Technical Service Bulletin

94 Headlight cracked / water ingress into headlight lens

94 14 42 2034735/2 May 29, 2014. Supersedes Technical Service Bulletin Group 94 number 13-25 dated July 24, 2013 for reasons listed below.

Figure 4. Upper headlight housing cracking.

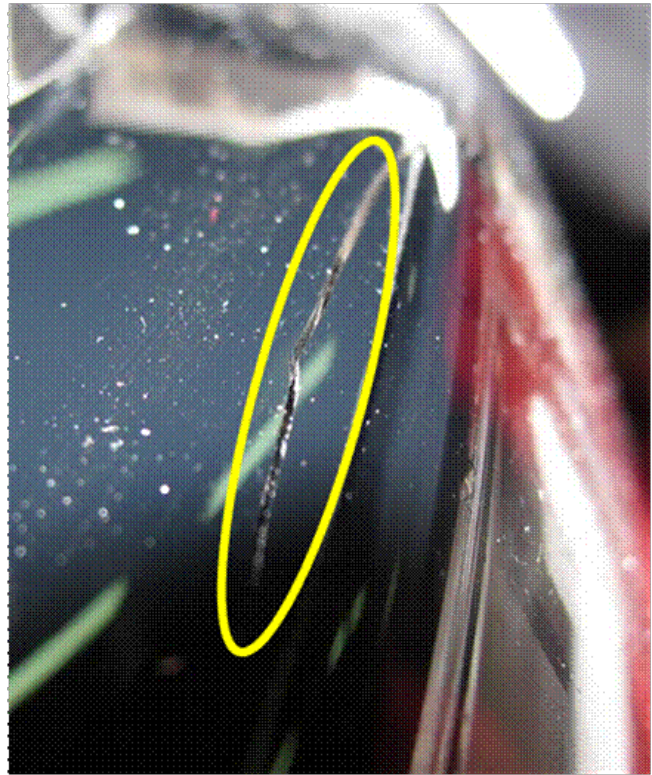
- Upper headlight housing cracking (at transition from lens to black surround) (Figure 4 and Figure 5).

Replace the affected headlight with the updated part number found in the ETKA parts catalog.
